**APQP Phase - PAST PROBLEM HISTORY (PPH)
(PAST QUALITY PROBLEMS)**

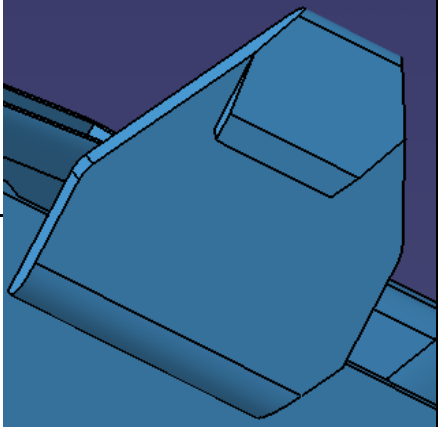
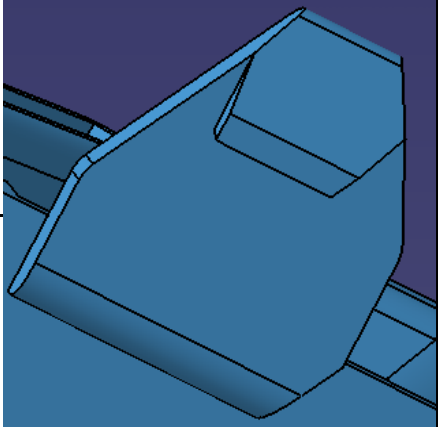
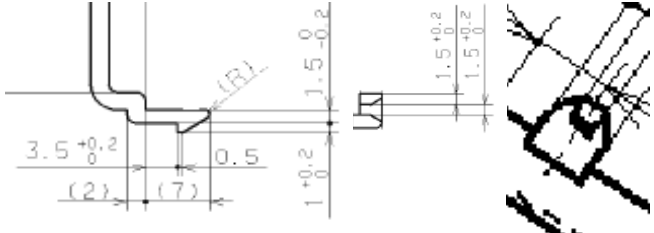
Item No.	Reference Information	Description	Example Picture
1	Plastic Components	Flash (Burr)	Functional area: None Handling area: 0.3mm or less Others: 0.5mm or less
2	Ejector Pin Marks	Excessive flash	
3	Gate Mark	Gate size too big, excessive flash size	
4	Misalignment of Upper and Base Cover	Protector deformation: Protector cover misalignment, warpage	 
5	6923-6918 PROT134RP6	Wrong shape during tool development: gate was added where dent can be seen	 
6	Female Locking Feature	Wrong shape during tool development	 
7	Surface Appearance	Unflat Surface (Not Matching Drawing)

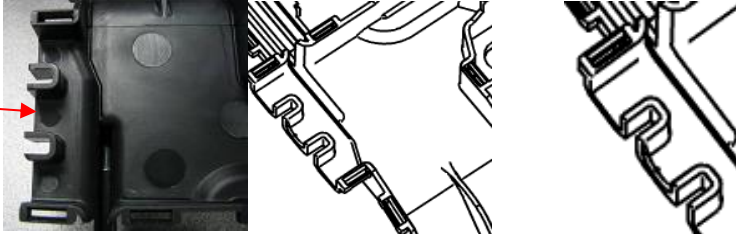
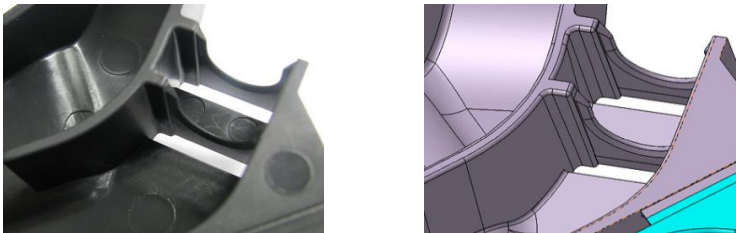
Item No.	Reference Information	Description	Example Picture
8	Male Locking Feature	Excessive flash	 
9	Male Locking Feature	Lock was found to have incorrect shape	 
10	Male Locking Feature	High insertion force, low retention force	 
11	Male Locking Feature	Male lock shape is incorrect	 
12	Female Locking Feature	1. Weld line on the female lock 2. Broken lock at engagement	
13	Female Locking Feature	Locks do not engage properly

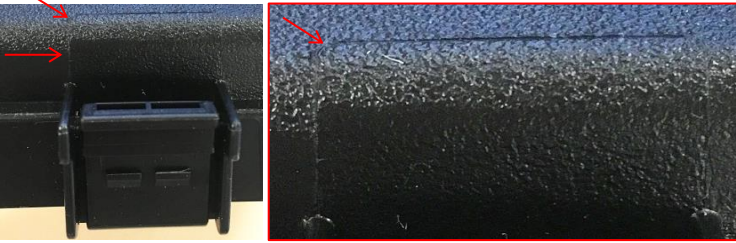
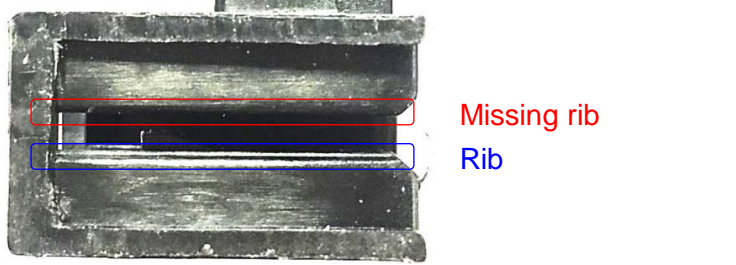
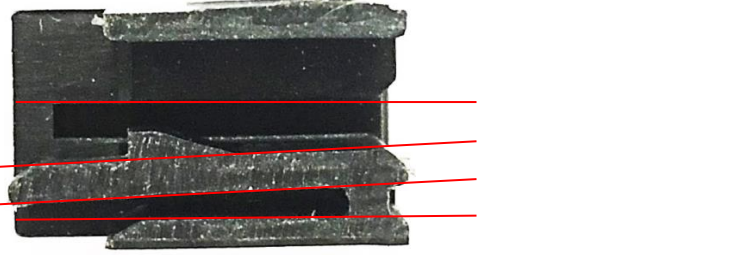
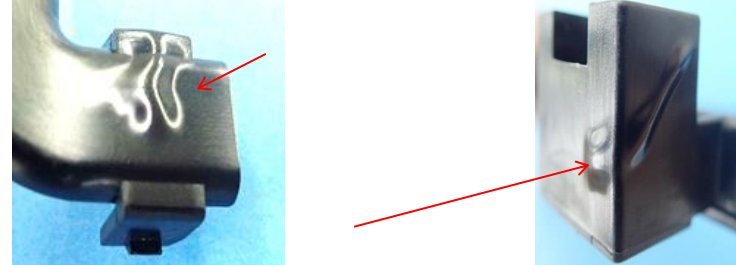
Item No.	Reference Information	Description	Example Picture
14	Rough Surface and Severe Lines on the Hinge	Rough surface, incorrect shape	
15	6923-6918 PROT134RP6	Supplier ID and part number engraving NG	
16	6923-7499 PROT129RK1A7	Sharp excessive flash inside the protector wall	
17	J/C connector	Flash on the mating feature	
18	6923-7816 PROT133R8A	Rib is missing	
19	corrugate tube holder	*Picture right is good sample part, but this is a reminder that corrugate rib cannot bemissing

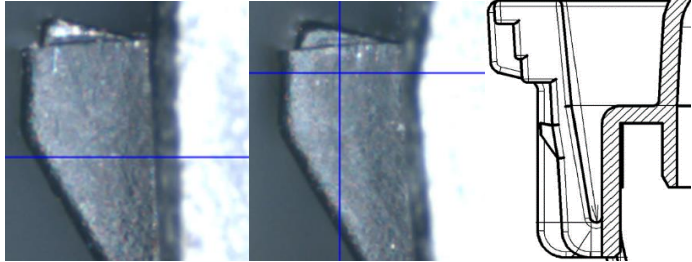
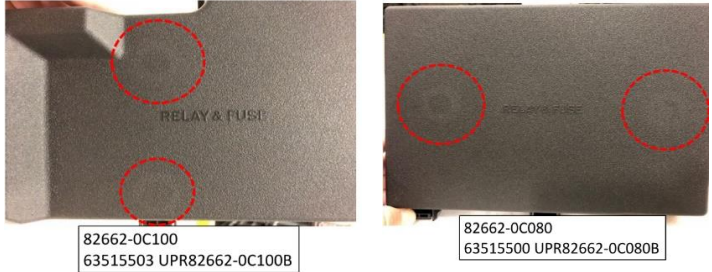
Item No.	Reference Information	Description	Example Picture
20	hinge	Broken hinge	
21	hinge	Wrong hinge shape, rough hinge surface	
22	bracket holder	Flash on the mating feature	
23	6923-9003 PROT1295J6	Unauthorized gate design and location	
24	6924-0306 PROT421TVA	Wrong Shape (Missing Radius)	
25	6924-0306 PROT421TVA	Gate - Wrong Shape (Un-match with TDRS)
